ROCK CREEK MESA
PRELIMINARY DRAINAGE REPORT

March 2026

Project No. 25.002547.00

STM-MP25-0358
STM-REV25-1181

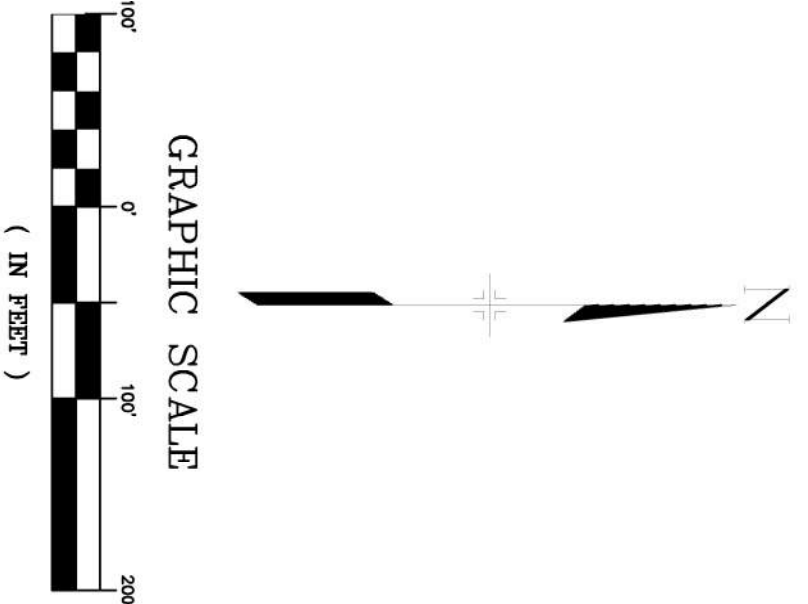
NO TREATMENT IN THE ROAD BED OR ADJACENT SHOULD BE PERMITTED TO CROSS THE ROAD OR THE POND UP TO THE MAXIMUM OF THE WQCV. THE TREATMENT SHOULD BE LOCATED TO THE DOWN-SLOPE OF THE ROAD AND THE POND UP TO THE MAXIMUM OF THE WQCV.

Why is this riprap greyed out? Is it existing or proposed?
